Subject: Transmittal of Revision 1 To Service Bulletin Number
V25000-ENG-72-0327.

International Aero Engines SERVICE BULLETIN

ENGINE - HIGH PRESSURE TURBINE ROTOR AND STATOR ASSEMBLY - INTRODUCE NEW
ROTATING PARTS WITH POTENTIAL FOR INCREASED CYCLIC LIFE

V2500-ENG-72-0327

Location Of The Stage 1 High Pressure Turbine Hub and The Stage 1 And 2 High Pressure Turbine Air Seals
Figure 1

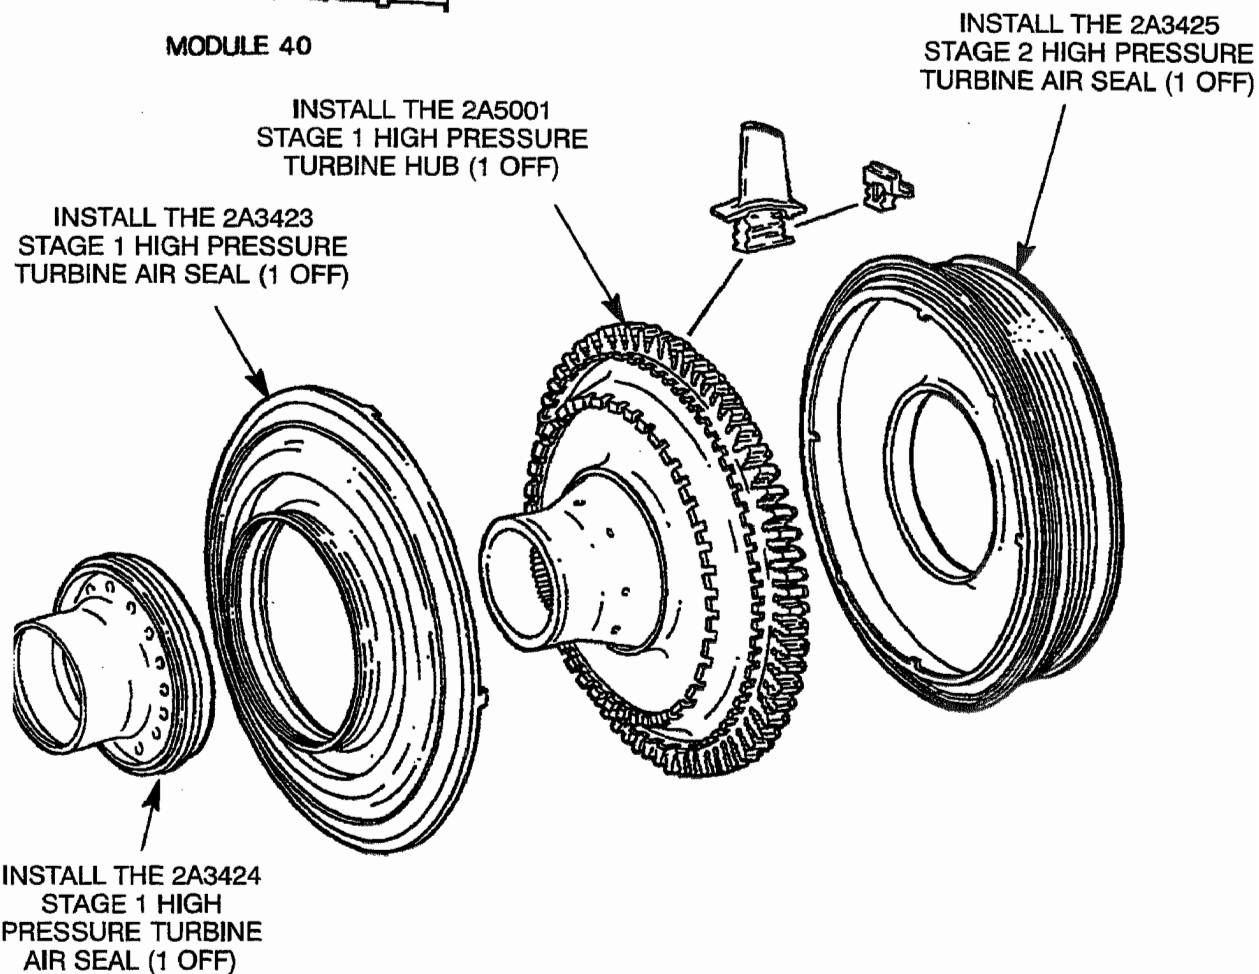
- A. Install a new Stage 1 High Pressure Turbine Hub and new Stage 1 High Pressure Turbine Air Seals when you assemble the 2A9021 Stage 1 Turbine Rotor Assembly by Figure 1 and as follows:

- (1) Install the 2A5001 Stage 1 High Pressure Turbine Hub by the procedure given in Reference 4 or 5, Engine Manual, Chapter/Section 72-45-10, Assembly.

- (2) Install the 2A3423 Stage 1 High Pressure Turbine Air Seal by the procedure given in Reference 4 or 5, Engine Manual, Chapter/Section 72-45-10, Assembly.

- (3) Install the 2A3424 Stage 1 High Pressure Turbine Air Seal by the procedure given in Reference 4 or 5, Engine Manual, Chapter/Section 72-45-10, Assembly.

Location Of The Stage 2 High Pressure Turbine Hub and Blade Retaining Plate
Figure 2

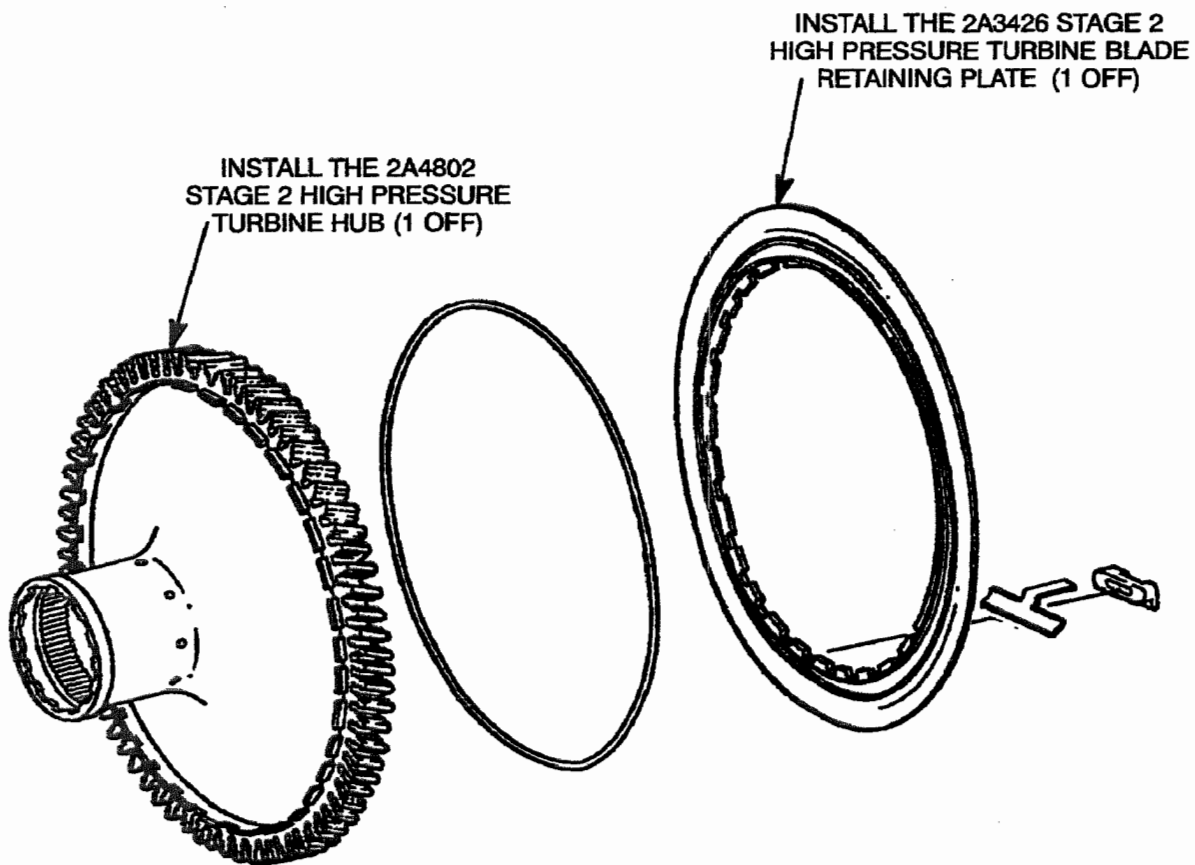
- B. Install a new Stage 2 High Pressure Turbine Hub and a new Stage 2 High Pressure Turbine Blade Retaining Plate when you assemble the 2A2622 Stage 2 Turbine Rotor Assembly by Figure 2 and as follows:

- (1) Install the 2A4802 Stage 2 High Pressure Turbine Hub by the procedure given in Reference 4 or 5, Engine Manual, Chapter/Section 72-45-30, Assembly.

- (2) Install the 2A3426 Stage 2 High Pressure Turbine Blade Retaining Plate by the procedure given in Reference 4 or 5, Engine Manual, Chapter/Section 72-45-30, Assembly.
